CORRIGENDUM -5

Dated: 22.04.2024

RFP for Design, Supply, Installation, Testing, Commissioning and Operation & Maintenance of Advanced Traffic Management System on Delhi to Agra Section of NH-19 on EPC mode

RFP Reference No.: IHMCL/ATMS/2023/03 published on dated 14.02.2024.

Annexure 2: Schematic Image of Walkable Gantry

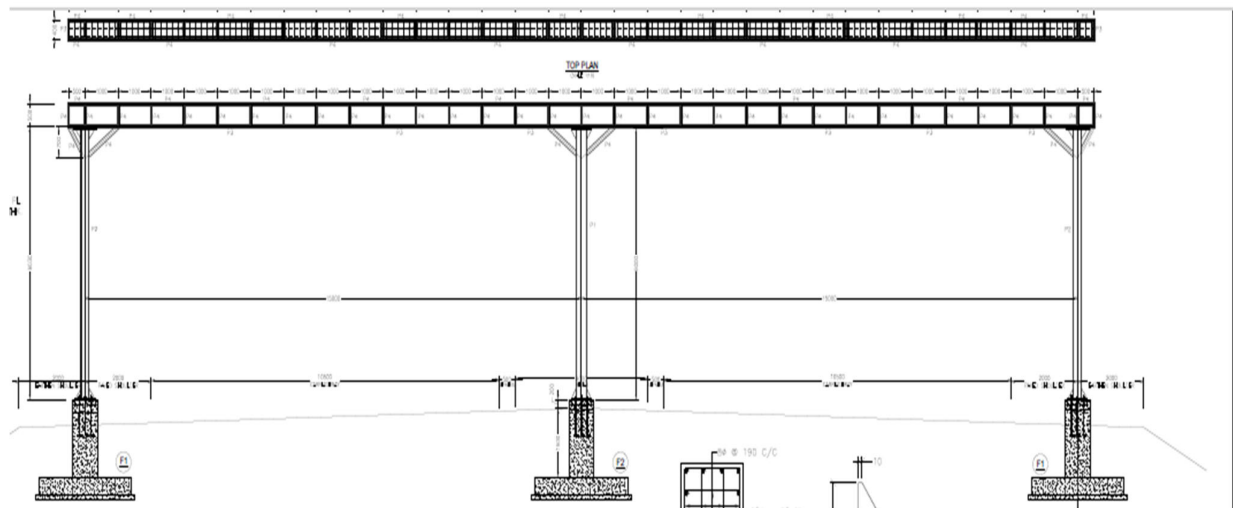
SI No	Section	Original RFP Clause	RFP Clause to be read as
			for third-party software to pull stored data/video/pictures by providing date, time, equipment id etc. which will be used for calculation of SLAs.
11.	Schedule C, Chapter 2, Clause 2.2.5, s.no. 17	New Clause	The Contractor should propose walkable gantries for ATMS Components. For reference schematic image of gantry is provided at Annexure 2 of Corrigendum.
12.	Schedule C, Chapter 9, Clause 9.6 Sl. No. 2 (a)	a) The Back bone OF Cable shall have a fibre count of minimum 12 fibres (24 cores). This cable shall not be used for any other connectivity.	a) The Back bone OF Cable shall have a fibre count of minimum 24 cores. This cable shall not be used for any other connectivity.
